7 SUB2008-00240

COLE'S PLACE SUBDIVISION, UNIT TWO, RESUBDIVISION OF LOTS 1 &2

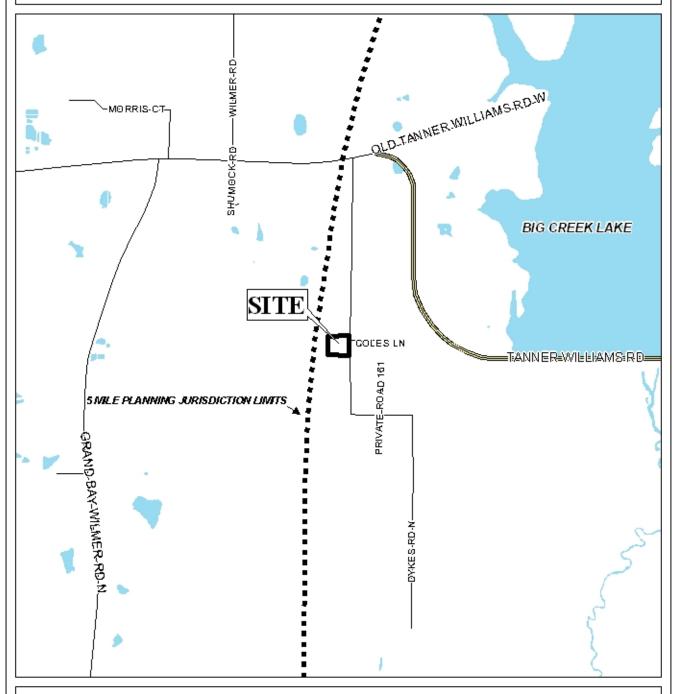
The site fronts on Dykes Road, a minor street with what appears to be an adequate 60' of right-of-way. The plat should be revised to show the existing right-of-way at this location. If 60' of right-of-way does not exist, dedication to provide 30' from centerline will be required.

Proposed Lots 1 and 2 have approximately 100' of frontage onto Dykes Road while proposed Lot 3 has approximately 228' of frontage. As a means of access management, a note should be placed on the final plat stating that Lots 1 and 2 are limited to one curb cut each onto Dykes Road and Lot 3 is limited to two curb cuts onto Dykes Road with the size, location and design of each curb cut to be approved by County Engineering.

A note should be placed on the Final Plat stating that any lots which are developed commercially and adjoin residentially developed property must provide a buffer, in compliance with Section V.A.7. of the Subdivision Regulations.

- 1) Placement of a note stating that Lots 1 and 2 are limited to one curb cut each onto Dykes Road and Lot 3 is limited to two curb cuts onto Dykes Road with the size, design and location of each curb cut to be approved by County Engineering;

- 4) Placement of a note on the final plat stating that any lot developed commercially and adjoining residentially developed property must provide a buffer, in compliance with Section V.A.7 of the Subdivision Regulations.
